Sydenham to Bankstown Metro: Key issues and opportunities

December 2017

Endorsed by Council 28 November 2017

The City of Canterbury Bankstown (Council) provides comment on the Metro Southwest EIS to highlight the significant city shaping opportunities that would be missed if the current plan was constructed as proposed.

Figure 5: TfNSW EIS Concept Plan for Belmore Station; annotated by Canterbury-Bankstown Council

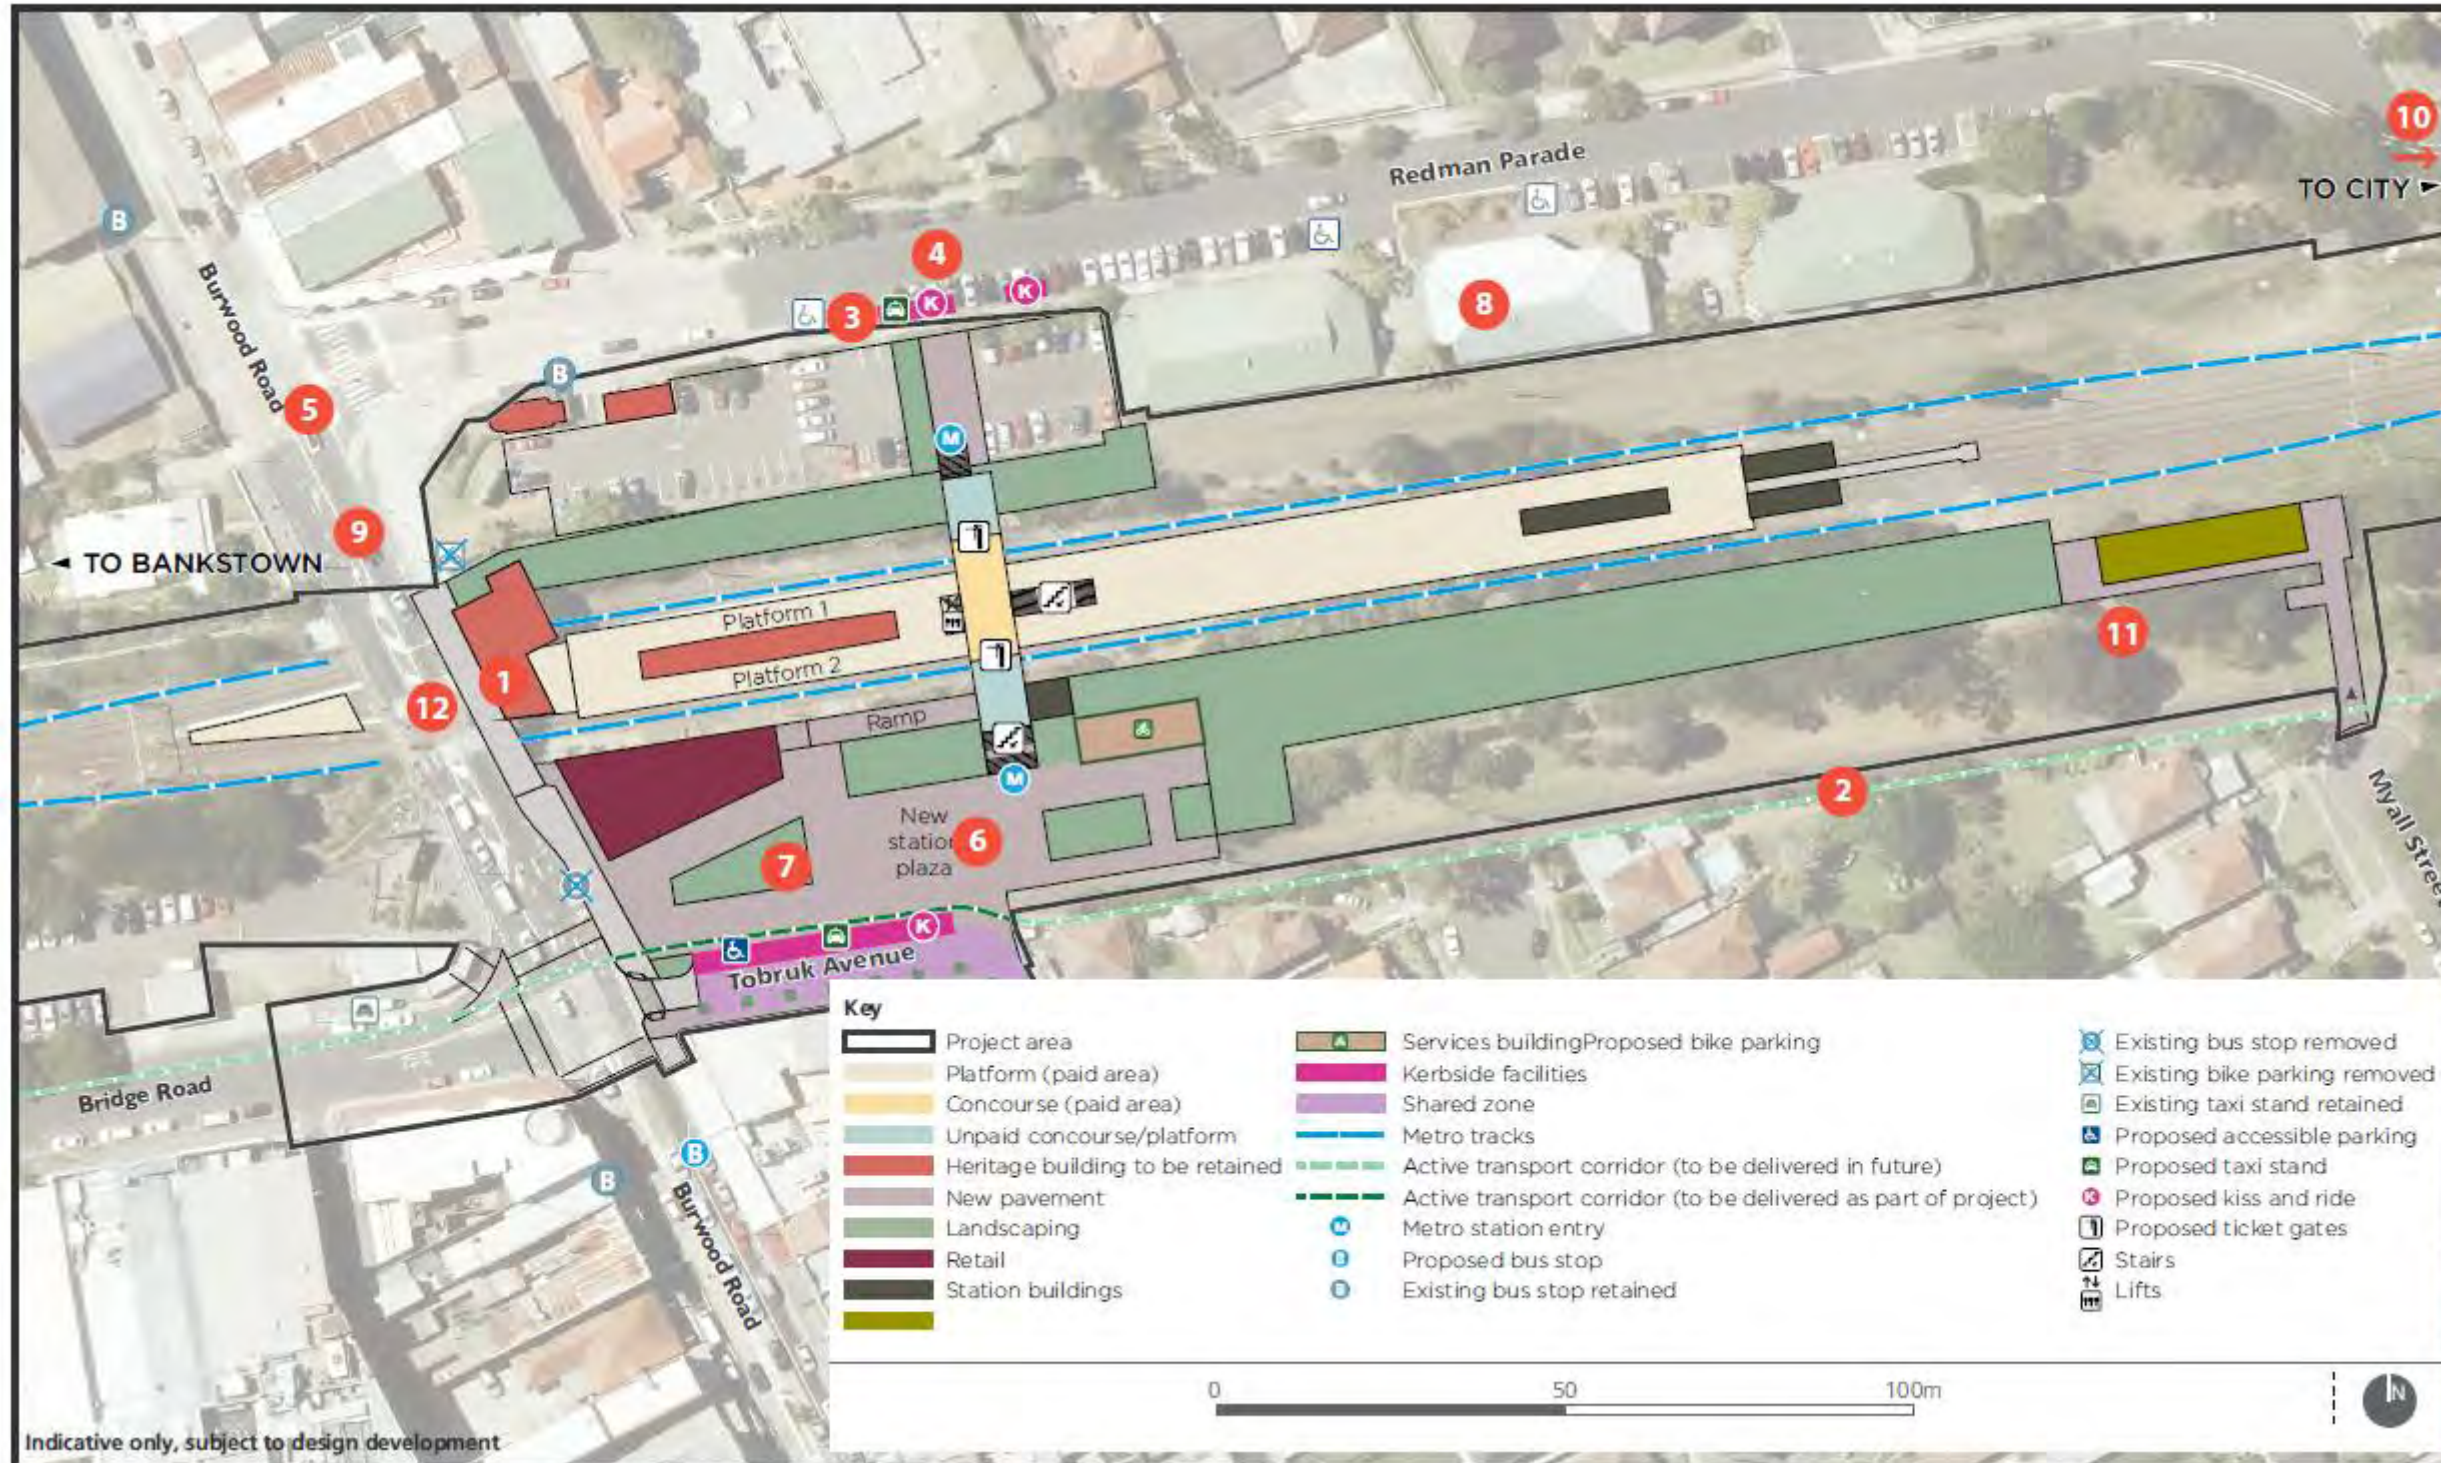
2	Connection to stadium - active transport corridor should be delivered first.	A note added to Figure 8.12 shows the Tobruk Avenue works, including the signalised intersection and active transport link to be constructed as 'early works' to allow the construction zone boundary to then be moved north of this area.	<ul style="list-style-type: none"> The Tobruk Avenue works, including the signalised intersection and active transport link to be constructed as 'early works'. 	<ul style="list-style-type: none"> The Tobruk Avenue active transport link to be constructed as 'early works' 	EIS: Table 8.7, Figure 8.12; TT&A Paper Section 8.8	13(2)
3	Rethink transport mode connections to station - kiss and ride too small, accessible parking location and bike parking removed from the station to the North	Show additional 'kiss and ride' bays on the southern side of the station potentially by converting the parallel bays to angled bays and accordingly slightly reducing the plaza area. Show bike parking on Figure 8.12 in the plaza area but also in the northern area of the station. This will also reduce the risk of vehicles queueing back out into Burwood Road because entering and exiting 'kiss n ride' bays will be easier/faster without potential reverse-and reduced risks with double parking.	<ul style="list-style-type: none"> Additional 'kiss n ride' bays off Tobruk Avenue and bicycle storage on the northern side of the station as well as the secure facilities proposed in the plaza area. 	<ul style="list-style-type: none"> Additional 'kiss n ride' bays off Tobruk Avenue by converting these bays to angled parking instead of parallel bays. 	EIS: Table 8.7, Figure 8.12; TT&A Paper Section 8.8	13(2)

4	Crossing required at Redman Parade in line with station entry	Include a pedestrian refuge, or road narrowing with pedestrian crossing or zebra crossing in EIS Figure 8.12 'to be delivered as part of the project'	<ul style="list-style-type: none"> Blister islands and a zebra crossing in Redman Parade aligned with the Metro station entry point 	<ul style="list-style-type: none"> A pedestrian refuge/crossing facility in Redman Parade aligned with the Metro station entry point 	EIS: Table 8.7, Figure 8.12; TT&A Paper Section 8.8	13(2)

11	Opportunity to increase pipe capacities through rail corridor to reduce/minimise flow through the pedestrian underpass near Belmore Oval.	Increase stormwater management capacity in the underpass.	<ul style="list-style-type: none"> Improvement to existing drainage and flooding issues. 	<ul style="list-style-type: none"> No deterioration to existing drainage and flooding issues. 	EIS: Table 21.2	6 (1) – (4)
12	Lighting on rail bridge, Burwood Road	Improved lighting on Burwood Road overbridge for pedestrians. Widen footpath for pedestrian safety during the day and night time periods in response to CPTED. Increased pedestrian safety to meet needs of future centre population is essential.	<ul style="list-style-type: none"> Widened footpath on Burwood Road overpass with suitable lighting for day and night time safety 	<ul style="list-style-type: none"> Additional lighting on Burwood Road overpass 		13 (1) (e)

Figure 6: TfNSW EIS Concept Plan for Campsie Station; annotated by Canterbury-Bankstown Council:

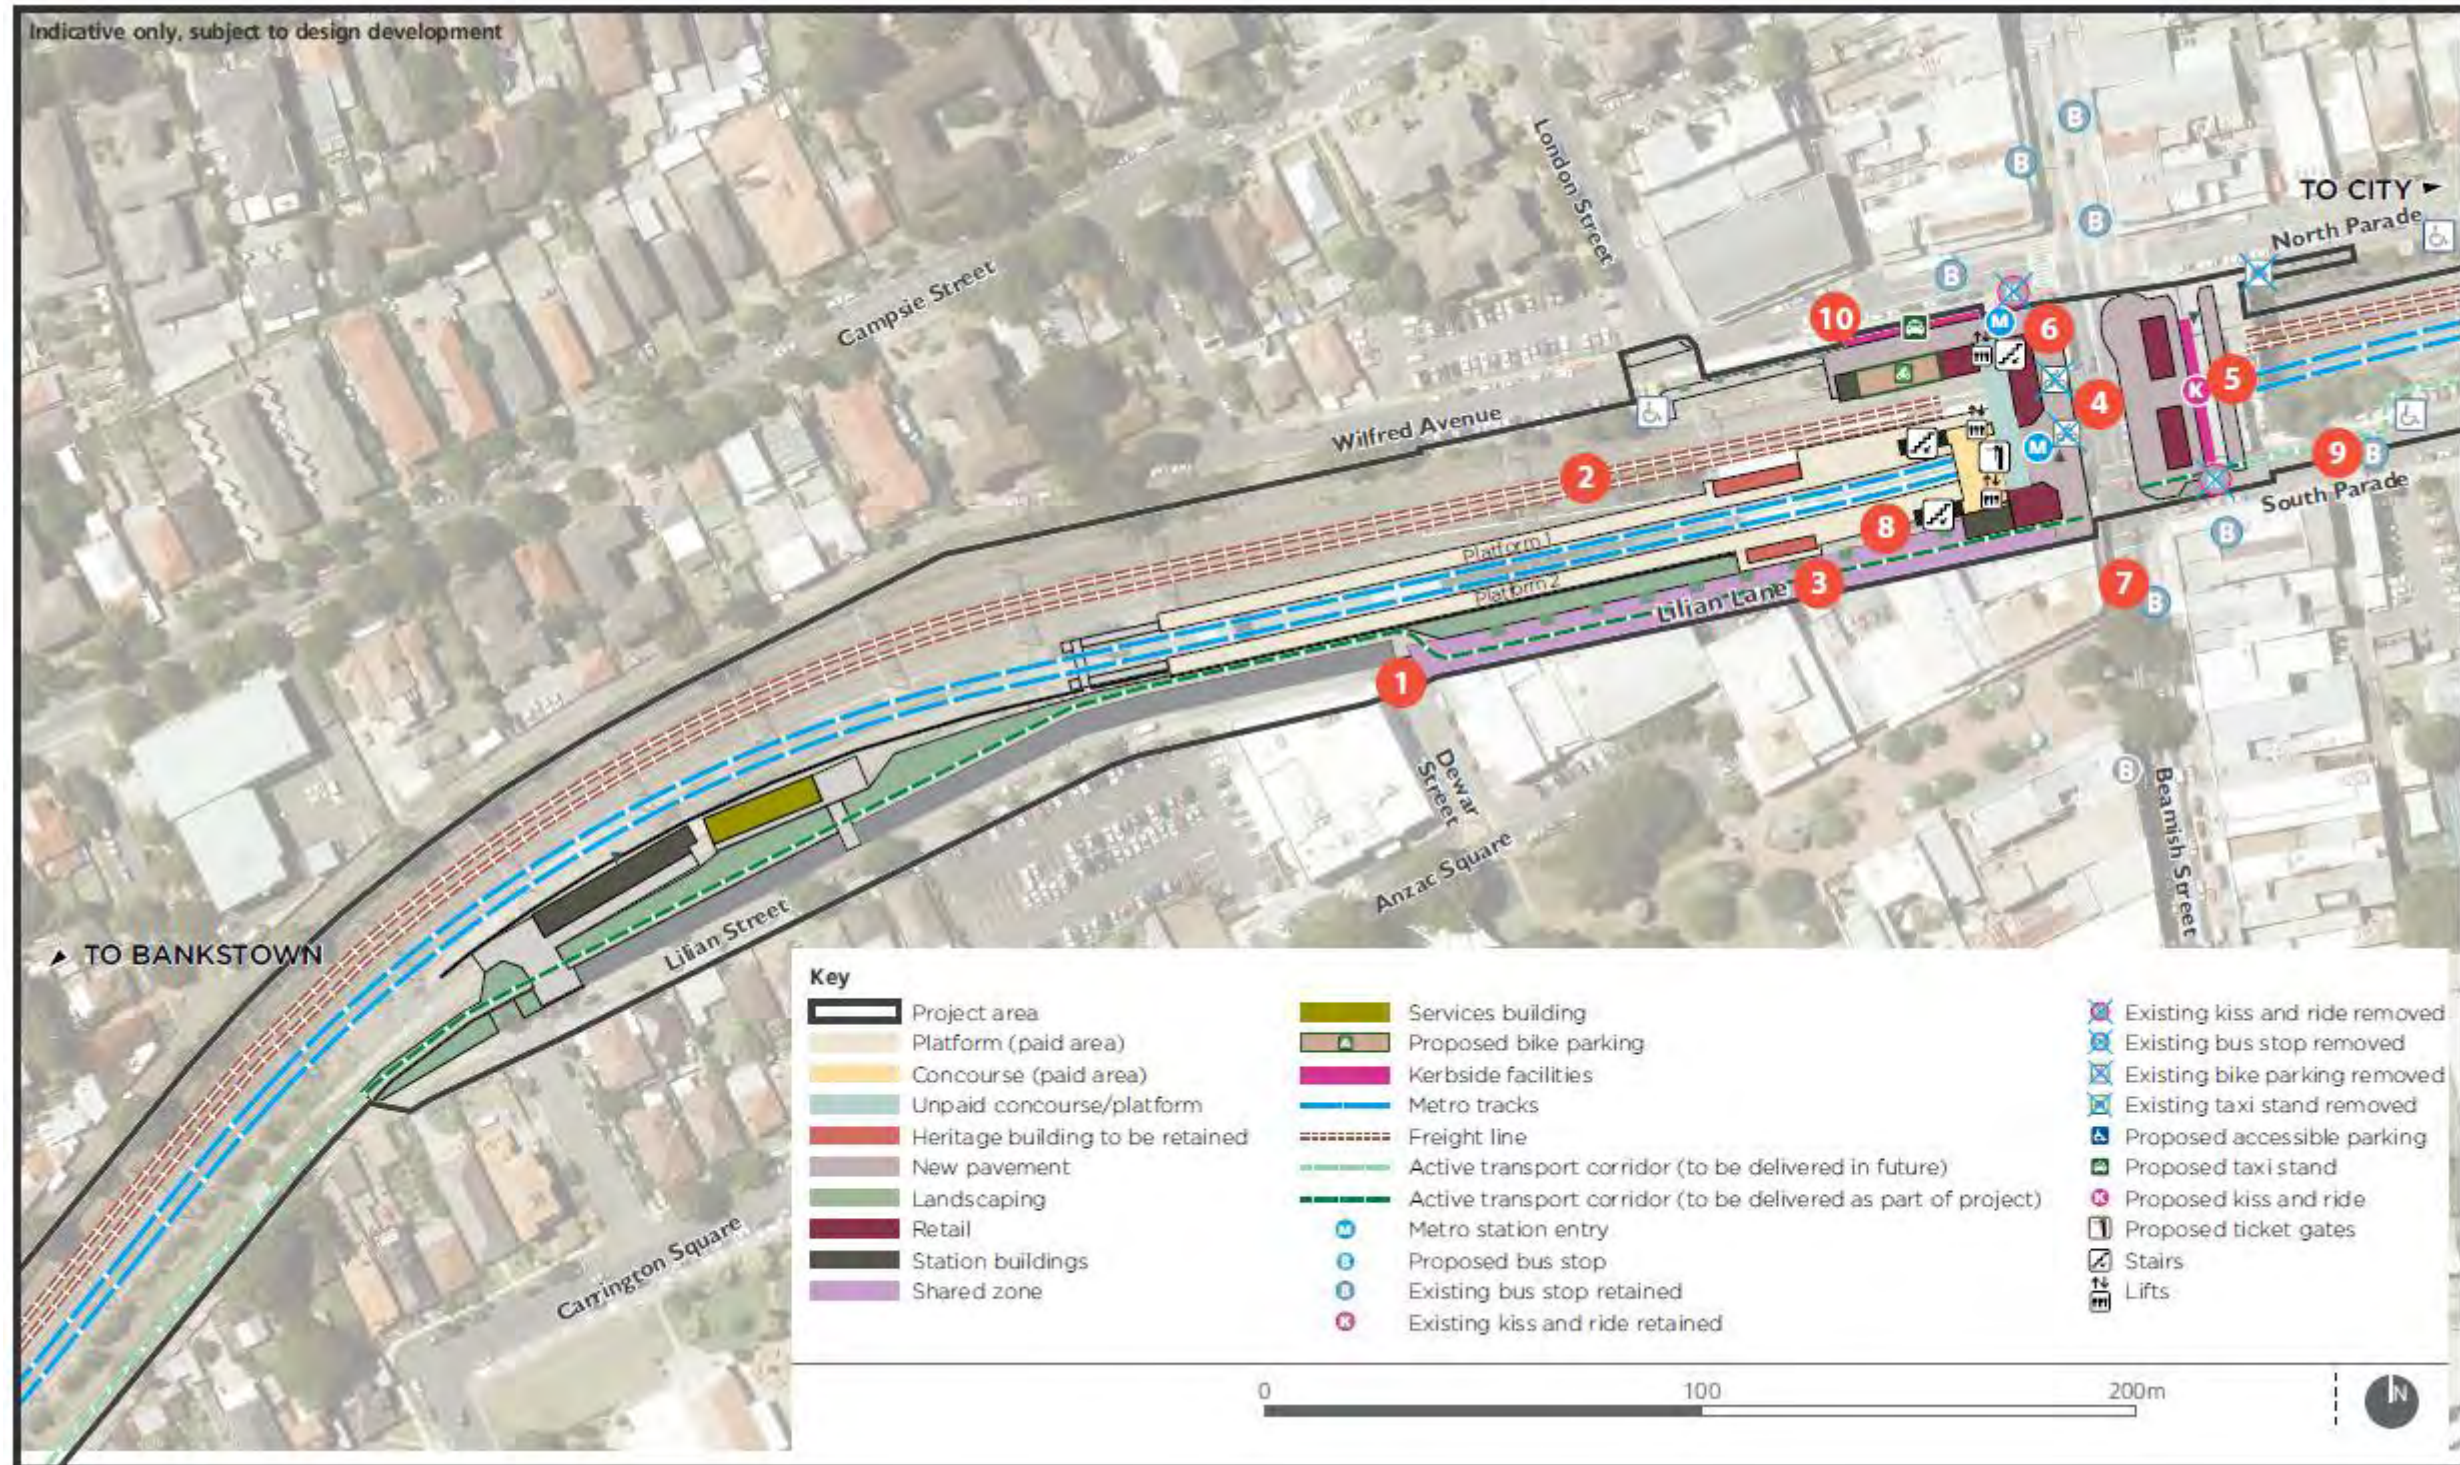
8	Need for additional secure bike parking - consider Lillian Lane.	Add the bicycle parking location near Lillian Lane to the station plan	<ul style="list-style-type: none"> • Secure bicycle parking near the station entrance off Lillian Lane 	<ul style="list-style-type: none"> • Bicycle parking near the station entrance off Lillian Lane 	EIS: Table 8.6, Figure 8.10; TT&A Paper Section 8.7	13(2)
9	Opportunity to Extend the Existing Cycle Path to Campsie Metro Station extend the existing cycle path along the Cooks River, ending at Tasker Park, by creating a dedicated Cycleway on South Parade from Wairoa Street to Beamish Street, including in front of the existing commuter car park	The cycle path will extend the existing active transport route to Campsie Station. The cycleway can be created in front of the commuter car park, and including water sensitive urban design into new landscaping features.	<ul style="list-style-type: none"> • Increase connections to existing cycleway 	<ul style="list-style-type: none"> • Increase connections to existing cycleway 	EIS: Table 8.6, Figure 8.10; TT&A Paper Section 8.7	13 (1)

10	Relocate kiss-and-ride to Wilfred Ave	Relocate kiss-and-ride to a logical location that is easy to see near station entry	<ul style="list-style-type: none">Relocate kiss-and-ride to a logical location that is easy to see near station entry	EIS: Table 8.6, Figure 8.10; TT&A Paper Section 8.7	13 (2)
----	---------------------------------------	---	---	---	--------
